## Addendum No. 001

Project: Blinn A & G  
Project No. 240566  
Date: 1/13/2025

Blinn Bldg A and G

BLINN BUILDINGS A & G

T0.0

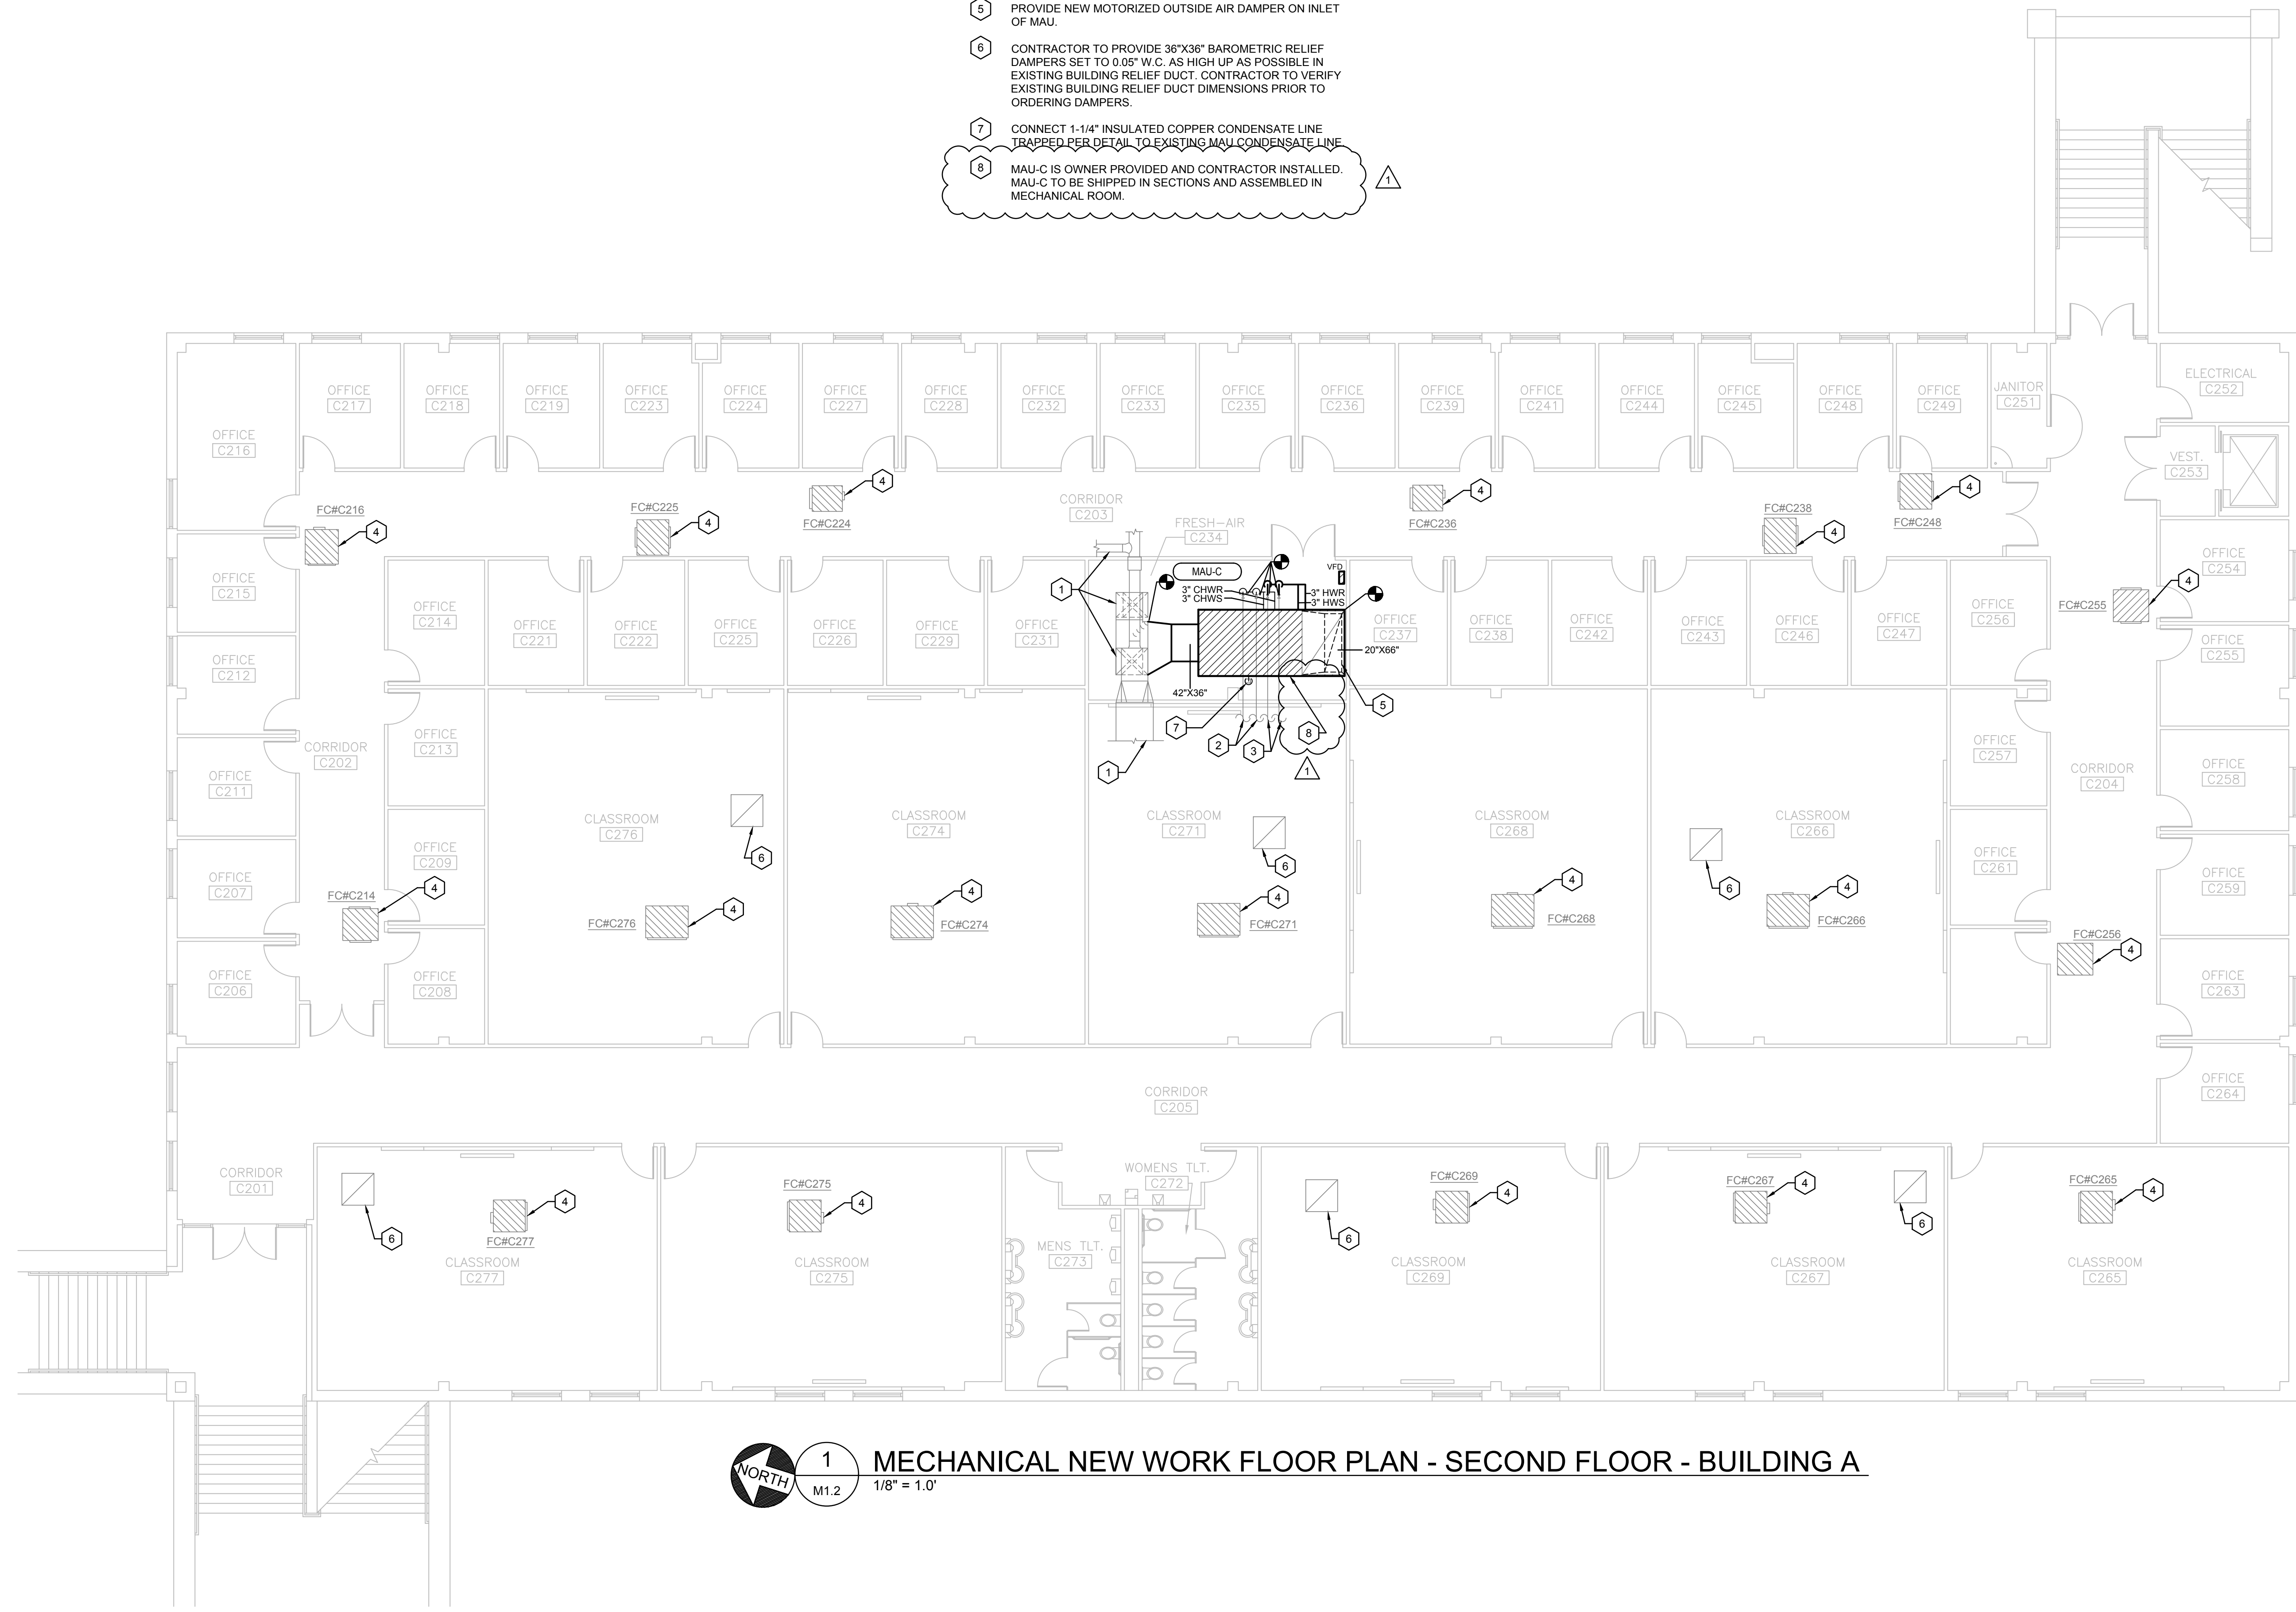
1. Sheet T0.0 – TITLE SHEET
  - a. Project location map has been added.
  - b. E2.3 has been added to the table of contents.
2. Sheet MD1.2 – MECHANICAL DEMOLITION PLAN – MECH ROOM – BUILDING G

**M1.2**

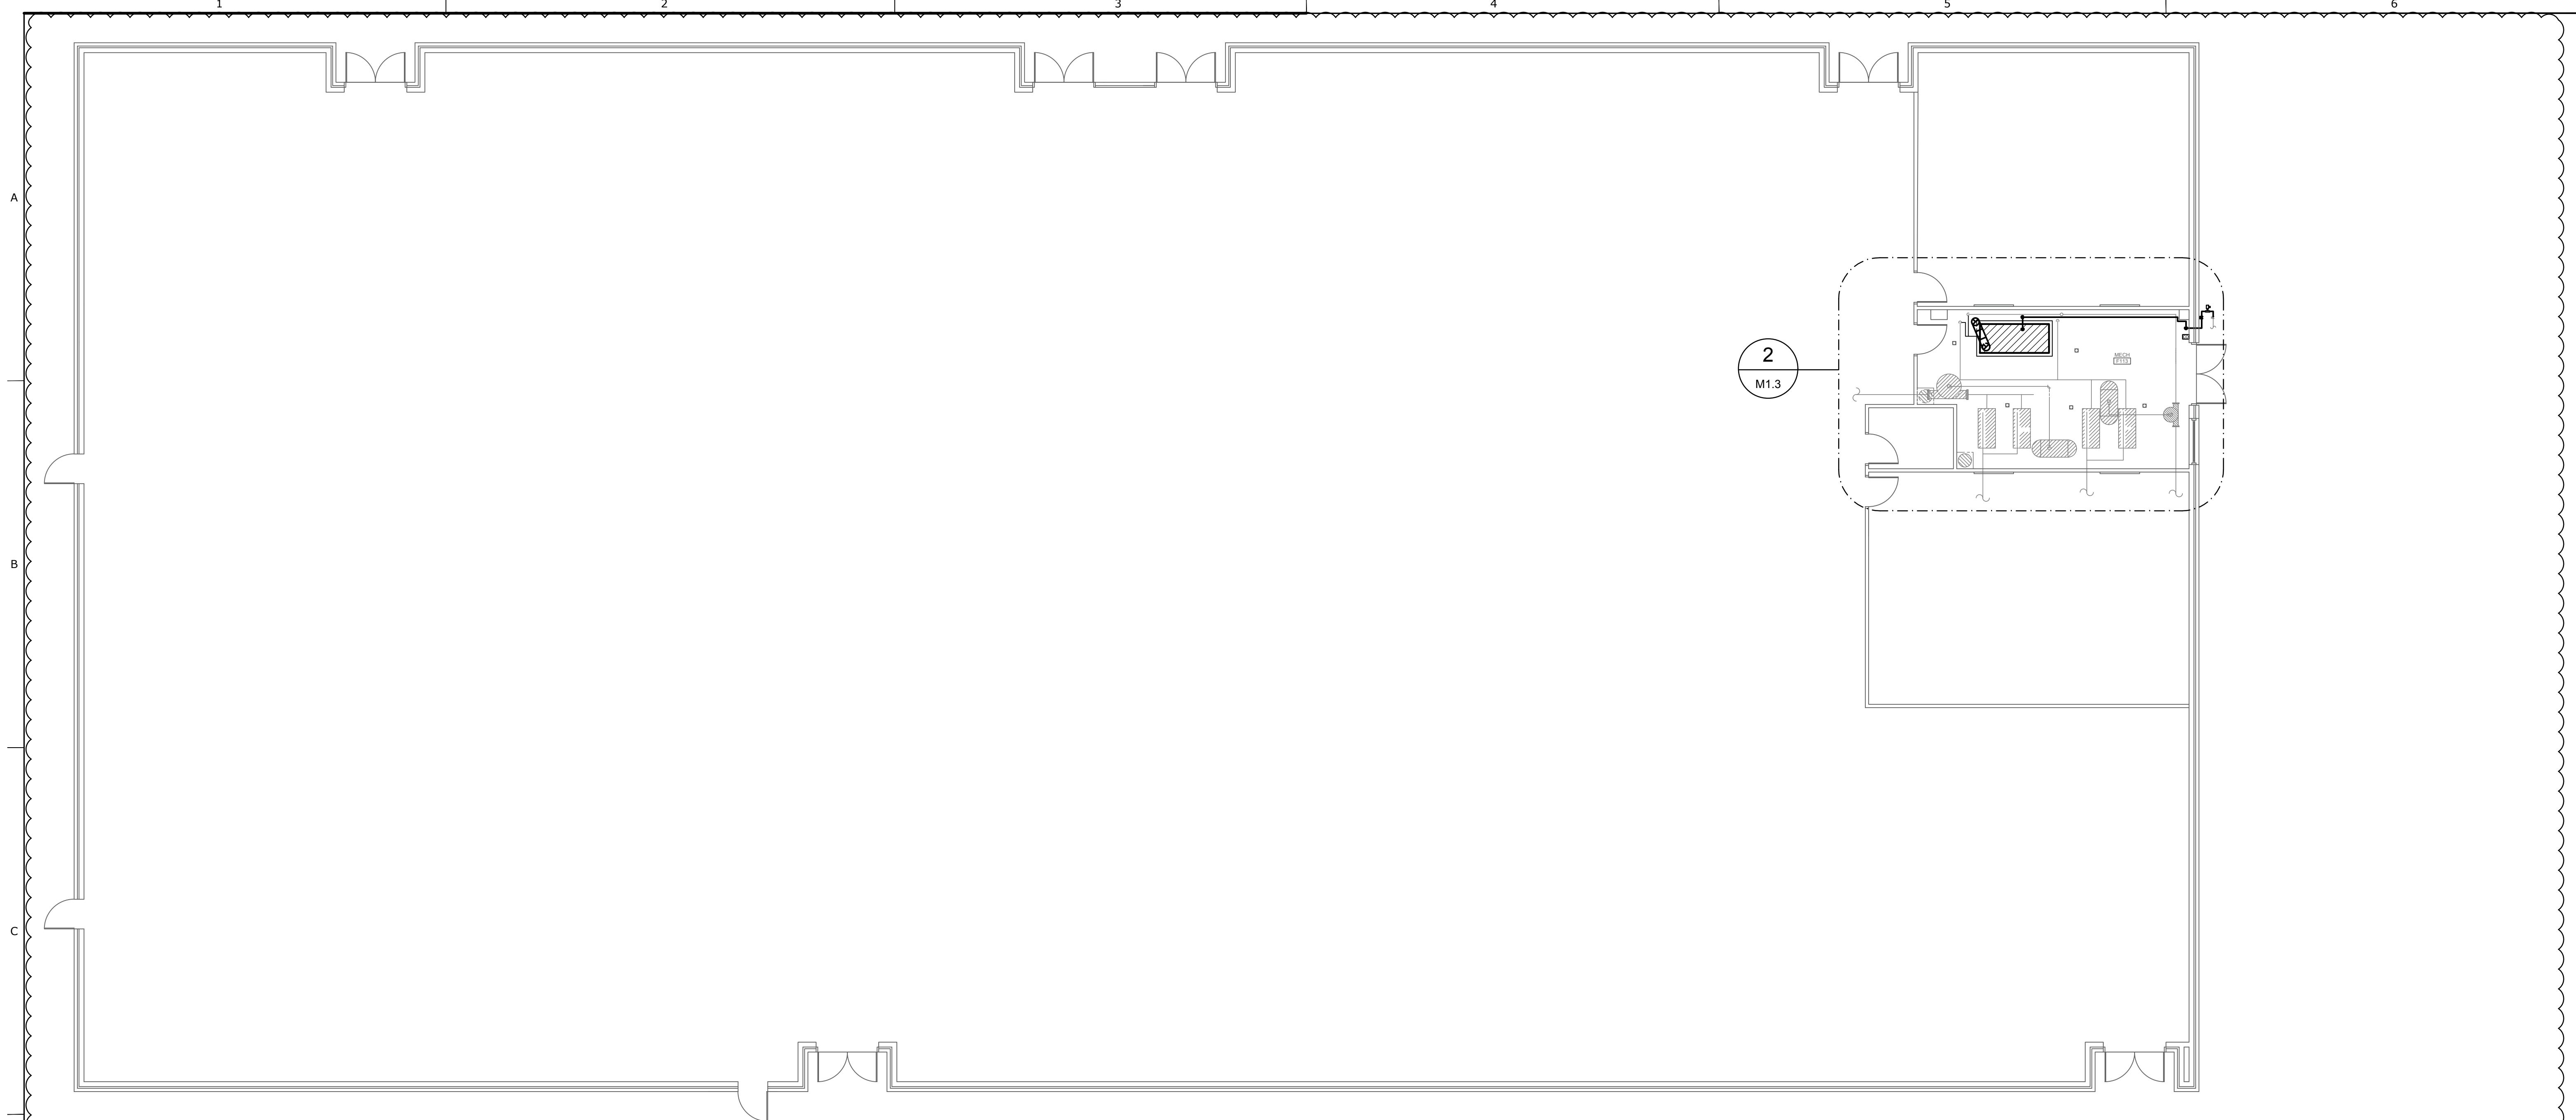
3. Sheet M1.2 – MECHANICAL NEW WORK PLAN – SECOND FLOOR – BUILDING A
  - a. Keyed note 8 has been added.
4. Sheet M1.3 – MECHANICAL NEW WORK PLAN – FIRST FLOOR – BUILDING G

**1** MECHANICAL NEW WORK PLAN - FIRST FLOOR - BUILDING G  
 M1.3 1/8" = 1.0'

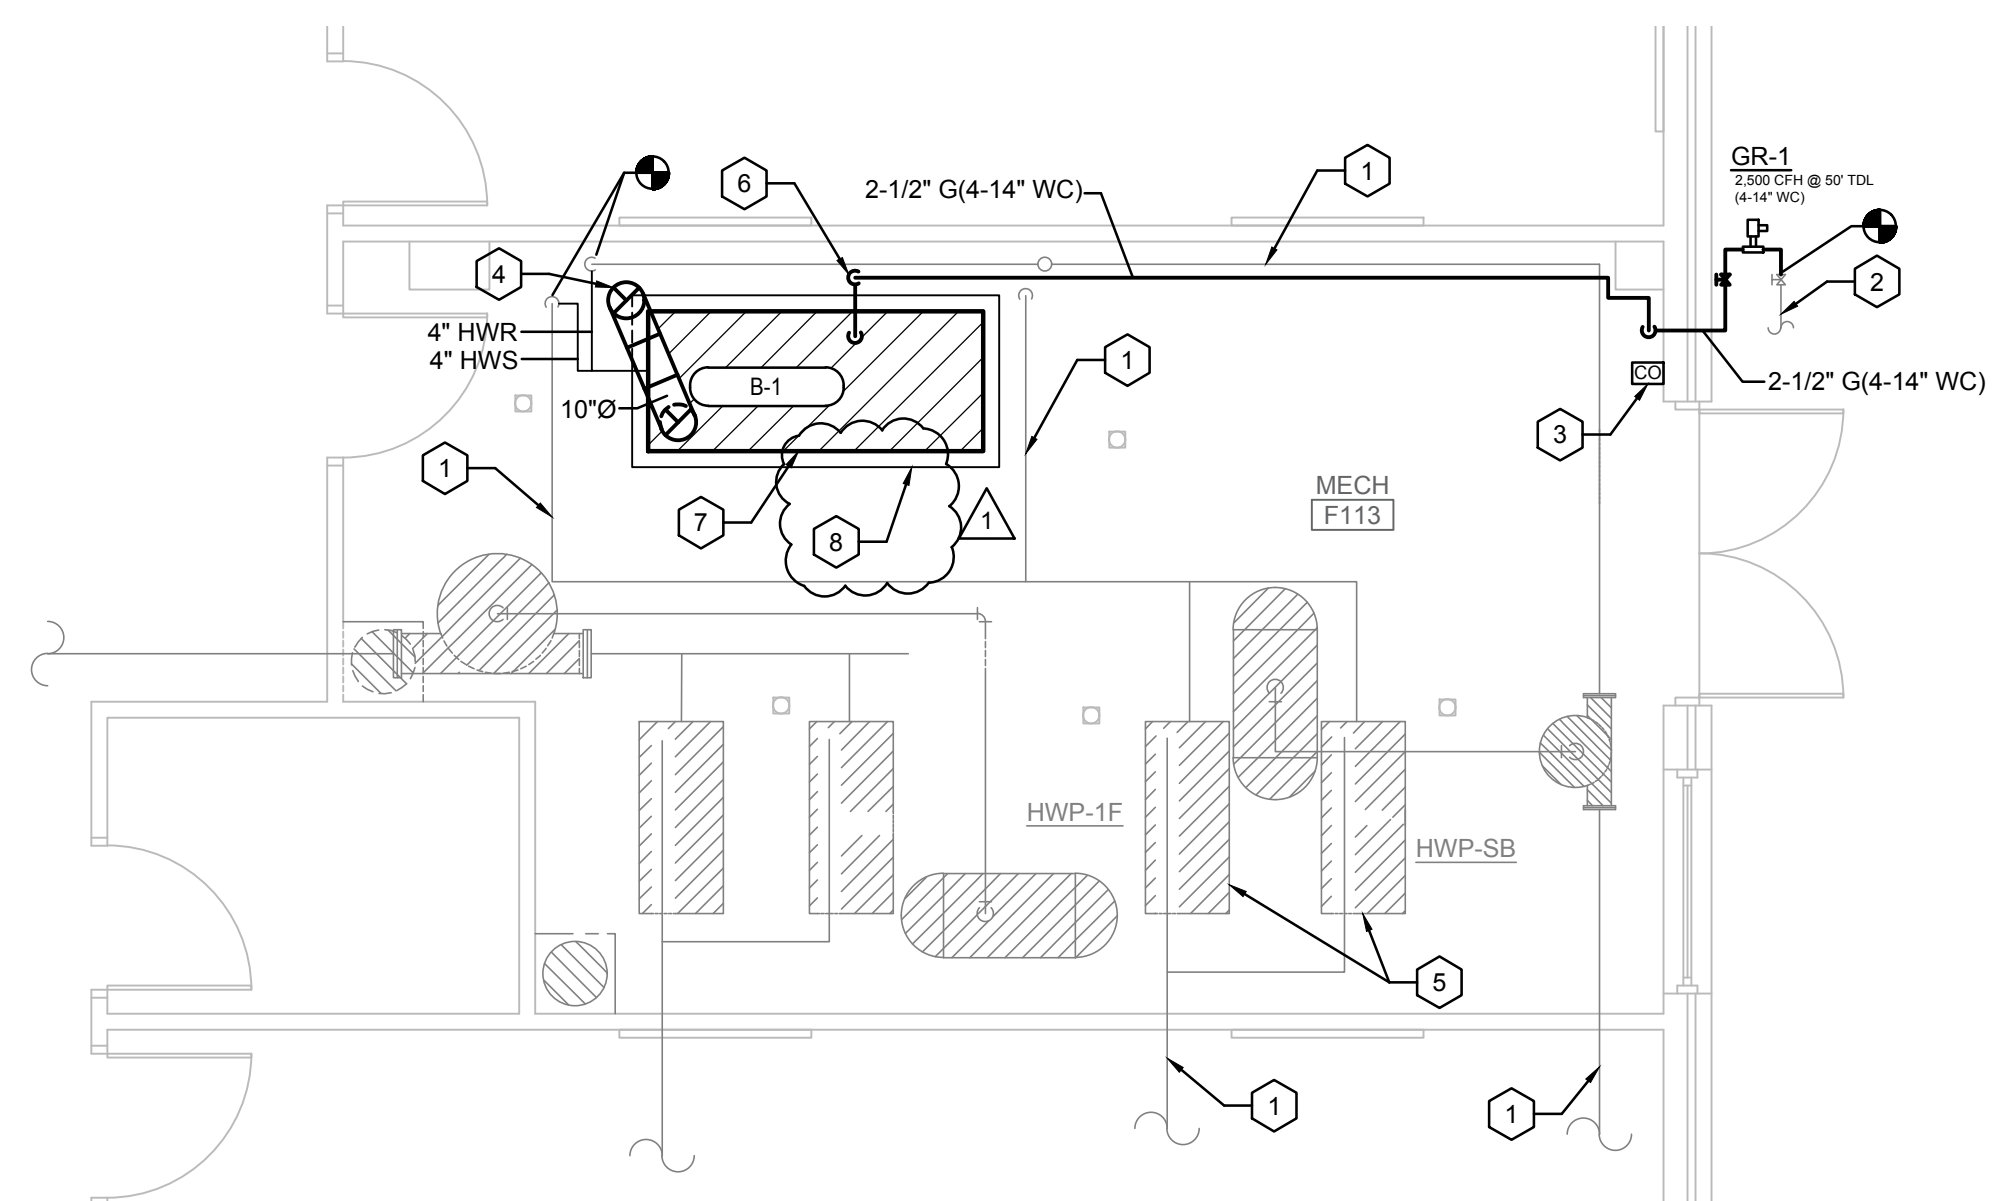
- a. Keyed note 7 has been modified.
  - b. Building G first floor plan has been added.
  - c. MECH F113 enlarged floorplan has been added.
  - d. 1/4" scalebar has been added.
